UNITED STATES PATENT AND TRADEMARK OFFICE

APPLICATION NO.	FILING DATE	FIRST NAMED INVENTOR	ATTORNEY DOCKET NO.	CONFIRMATION NO.
10/604,112	06/26/2003	Shahid Butt	FIS920030087	1111

Office Action Summary

DETAILED ACTION

**Fig. 8**

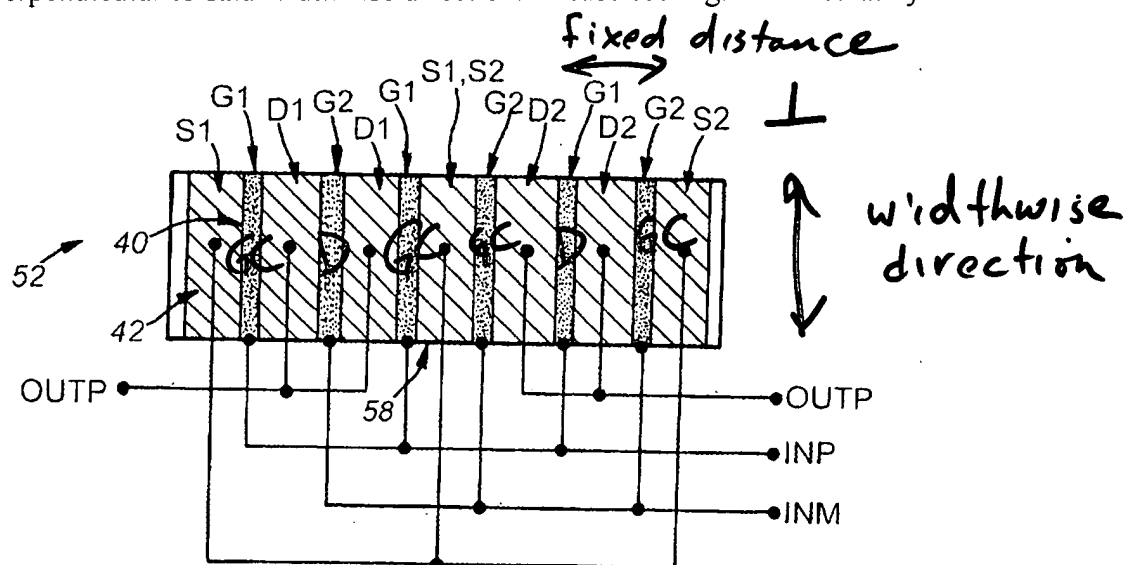
U.S.C. 102(b) as being anticipated by Nakamura 5,767,542. Nakamura discloses (see, for example, Fig. 8) an array of field effect transistors (electronic device) comprising a P substrate (semiconductor substrate) 46, dummy gate conductors G2 of M1D, G1 of M2D; and gate

conductors G1 of M1, G2 of M2. The gate conductors are positioned substantially parallel to each other in a widthwise direction and periodically spaced apart a fixed distance in a direction substantially perpendicular to said widthwise direction. Please see Fig. 8 immediately below.

Regarding claims 9, 10, 20, and 21, see, for example, Fig. 8 wherein Nakamura discloses source regions S1 and drain regions D1 which are also n⁺ wells.
